ITEM: 6.6	COMMITTEE OF ADJUSTMENT REPORT SUMMARY MINOR VARIANCE APPLICATION FILE NUMBER A046/23 138 THORNRIE DRIVE, THORNHILL
------------------	--

**COMMITTEE OF ADJUSTMENT REPORT
MINOR VARIANCE APPLICATION
A046/23
138 THORNRIIDGE DRIVE, THORNHILL**

#	Zoning By-law 001-2021	Variance requested
1	The maximum permitted lot coverage is 23%. [Section 7.2.2. Table 7-3, Footnote (2)]	To permit a maximum lot coverage of 25.86%.

Drawing Title	LOT GRADING PLAN	
Project No.	DES18-06-03A	
Drawn by	J.H.	
Checked by	F.F.	
Date	MAR 29, 2023	
Drawing No.	A1.0	
Scale	AS SHOWN

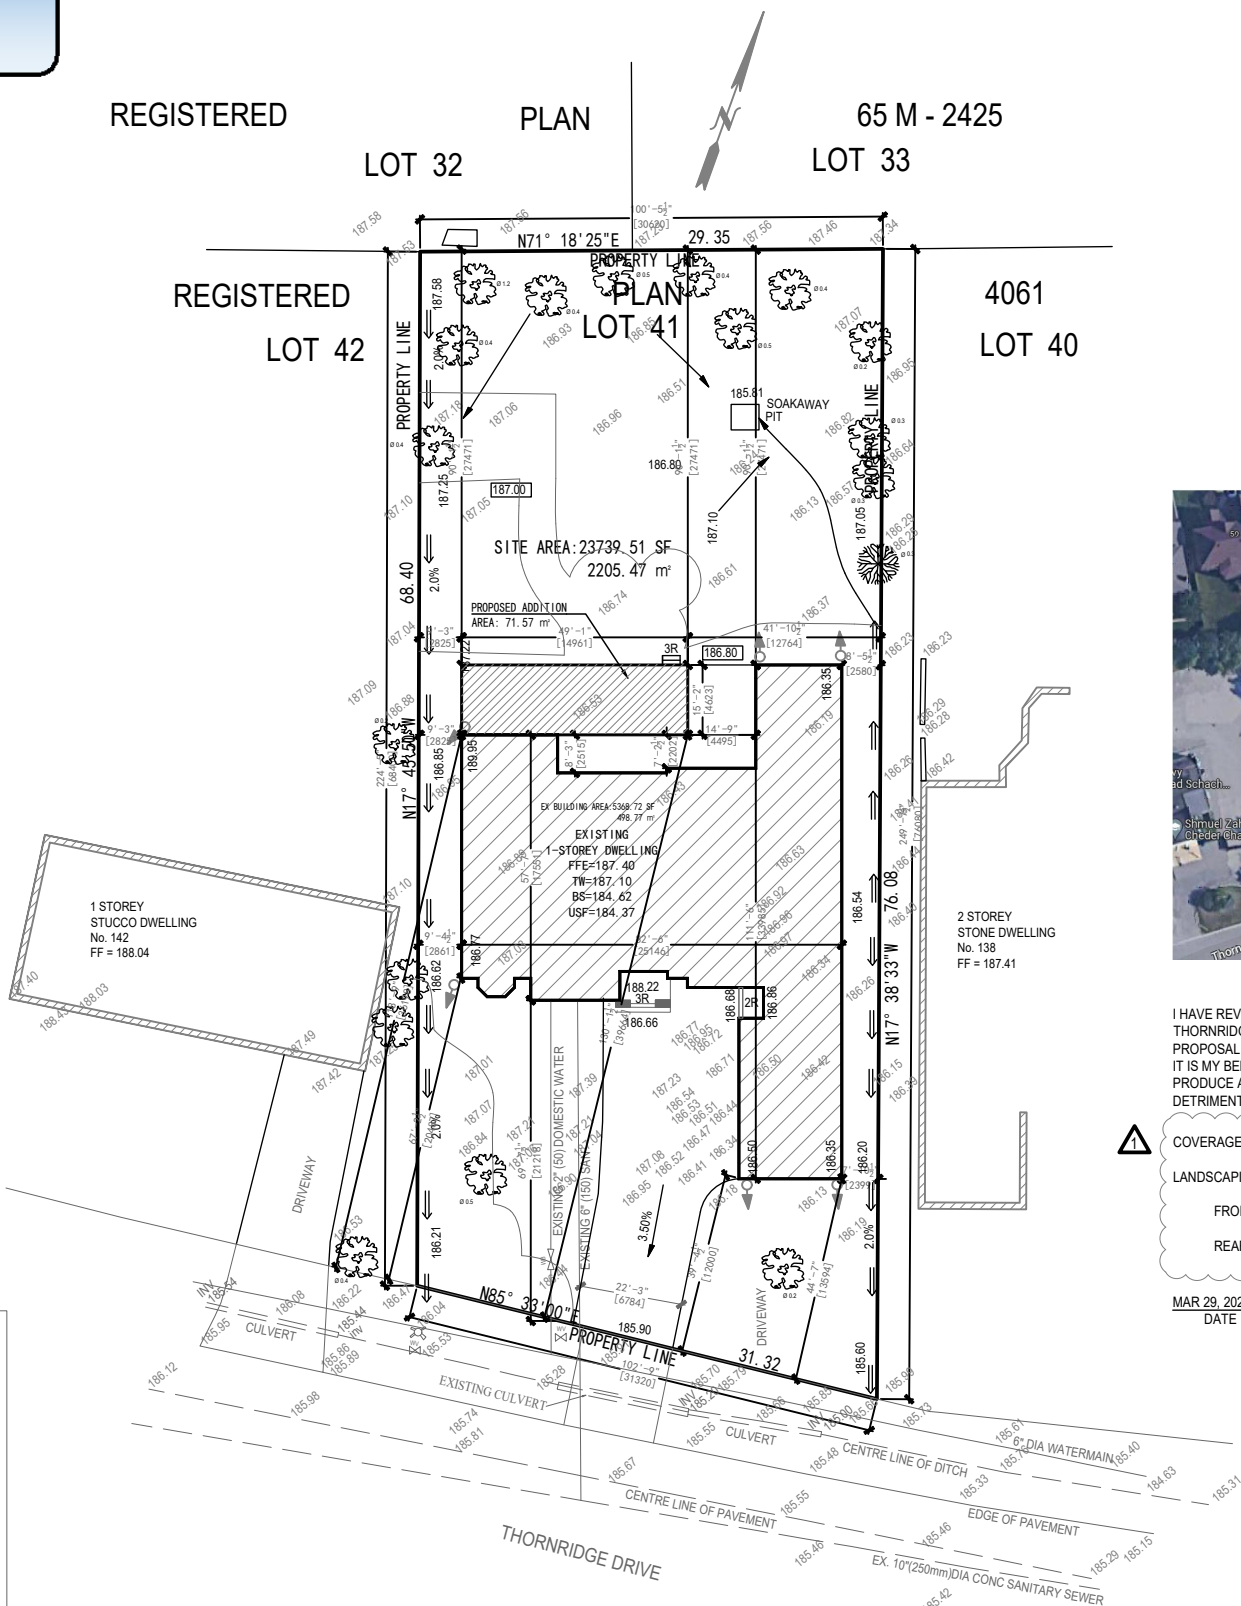
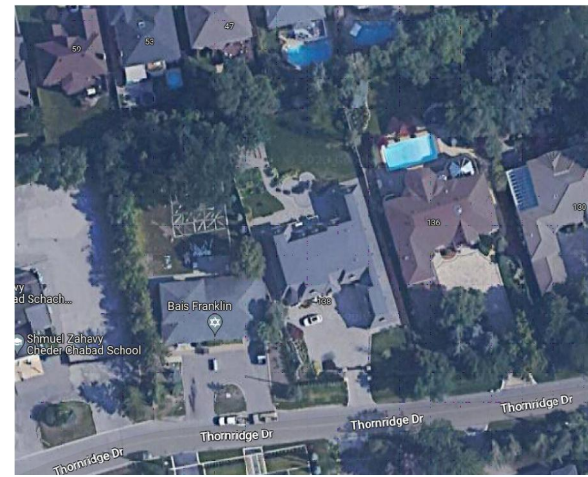
As the proposed addition to existing residence is 71.57 m² in the subject property, the Owner / Applicant needs to obtain a Lot Grading Permit from Development Inspection and Lot Grading Division of the City's Development Engineering Department. Please note any in-ground structure over 10 m² requires a Grading Permit. Please contact the Development Engineering Reviewer after receiving the Grading Permit to clear the condition. (Condition attached)

The proposed work by the Owner / Applicant is increasing the lot coverage on the subject property. The added hardscape may have impacts on the City's Storm Water management system. Development Engineering strongly encourages the Owner / Applicant introduce Low-Impact Development (LID) measures (e.g., bioswales, permeable pavers, rain gardens, rain barrels etc.) to reduce the impacts to the stormwater system. Should further information be required, please contact the Development Engineering COA reviewer.

Development Engineering Recommended Conditions of Approval:	The Owner / Applicant shall submit the final Lot Grading and/or Servicing Plan to the Development Inspection and Lot Grading Division of the City's Development Engineering Department for final Lot Grading and/or Servicing Permit prior to any work being undertaken on the property. Please visit the Grading Permit page at City of Vaughan website to learn how to apply for the Grading Permit. If you have any questions about Grading Permit, please contact the Development Engineering Department by email at DEPermits@vaughan.ca .
--	---
